Committee on Tidal Hydraulics

Minutes of the 104th Meeting

18-20 April 1995

John F. Baldwin Project, Phase III

Comparison of Maximum Salinity Impacts

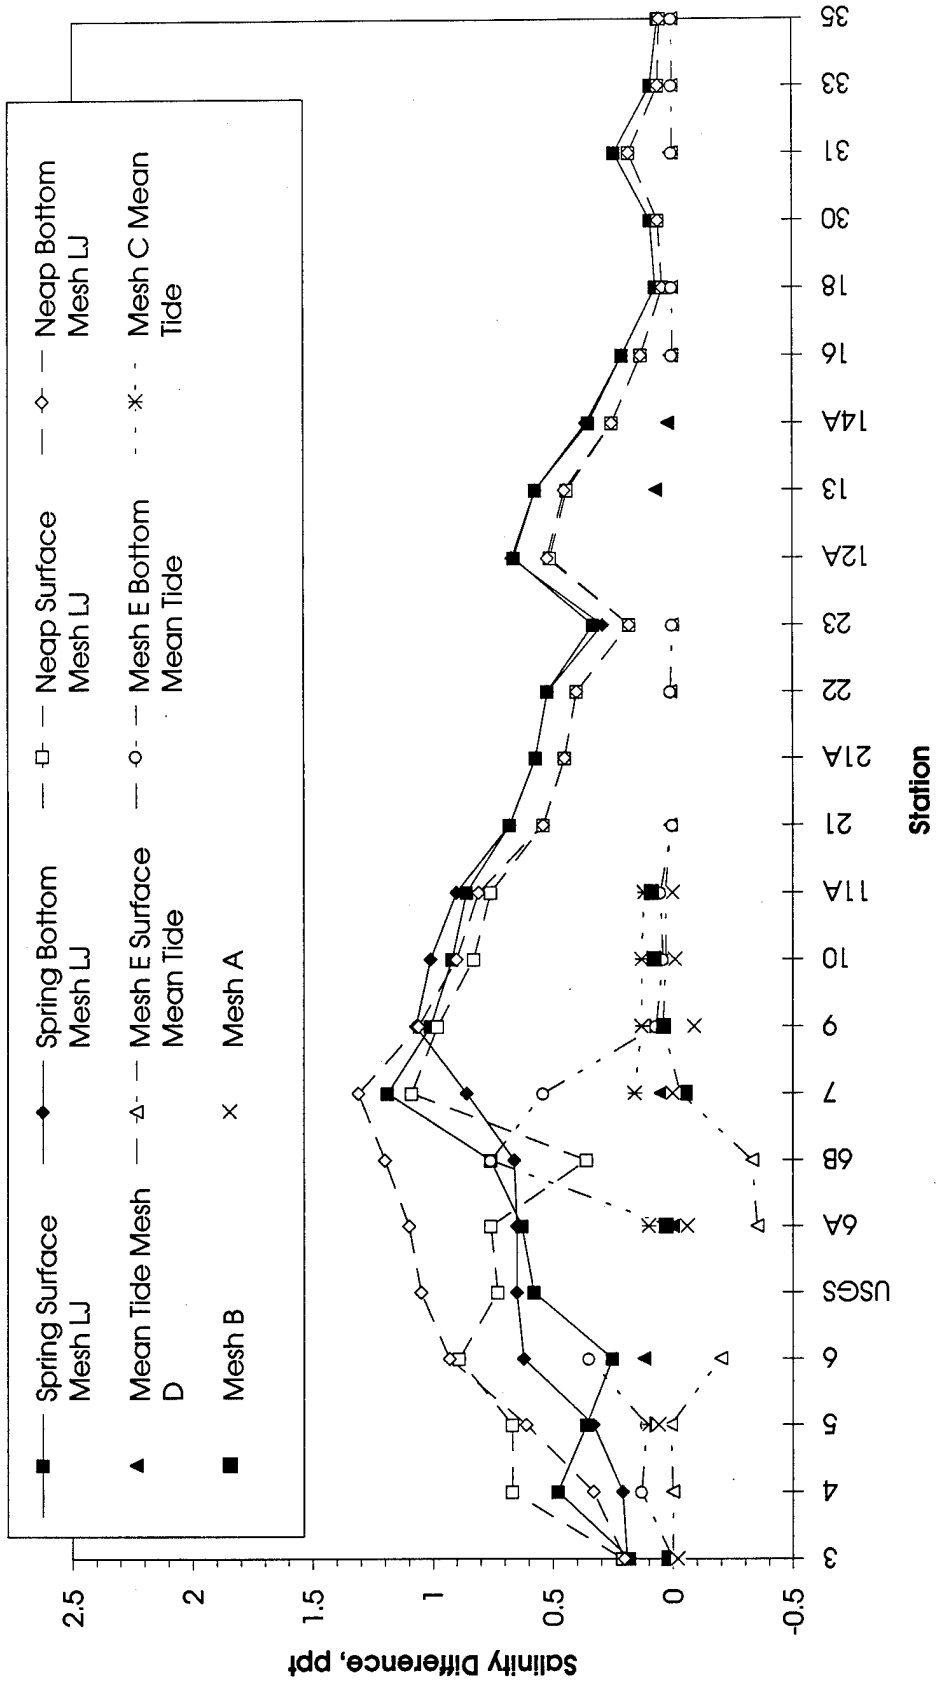
19. Enclosure 3 shows JFB salinity change results from the several numerical models. Models A-E showed maximum salinity change effects of the JFB project to be from about 0.4 ppt fresher (at the surface in Carquinez Strait with Model E) to 0.8 ppt saltier (near bottom in Carquinez Strait with Model E). At Chipps Island, a standard measuring point in prior studies, Models A-E showed maximum salinity increases of about 0.1 ppt, whereas Model LJ indicated an increase of about 0.9 ppt. Base salinities at the Chipps Island station were about 5 ppt. Mr. McAnally showed a series of video clips displaying animated salinity contours.

20. The lower salinity change predictions of numerical Models A-E are consistent with the physical Bay Model predictions of JFB effects, but since those numerical models were verified to the

physical model, agreement is not independent confirmation of the effect. The following are possible reasons for the differences of Model LJ:

- a. The Model LJ test was the only one in the full series of physical and numerical tests to use a neap range to spring range variable tidal boundary condition instead of the repetitive 19-year mean tide. It has been recognized in some prior physical model studies (e.g., Chesapeake Bay, Columbia River, Cape Fear River) that salinities with neap-spring tides can be significantly different from the artificial repetitive mean tide. If San Francisco Bay responds in a similar nonlinear fashion, the Model LJ results could be more realistic than previous test results.

- b. Models A-E were verified to the physical model channel salinity results, and Model LJ is the first of the numerical models in this series to generate fully independent results. The difference may be indicative of the range of accuracy of both the physical and numerical model predictions, or indicate error in either model.

- c. The Model LJ test from which these differences were taken may not have been fully spun up—the salinity values were not necessarily independent of the initial test conditions. If base and plan tests were approaching full spin-up at different rates, the difference between base and plan salinities could be in error.

- d. The two models may be using slightly different bathymetric data.

21. The San Francisco District has tasked WES with conducting additional tests to explore these potential explanations of the model differences. The initial test of this series—running Model LJ with the same boundary conditions as the physical model, including the mean tide—is underway and will be complete within a few weeks.
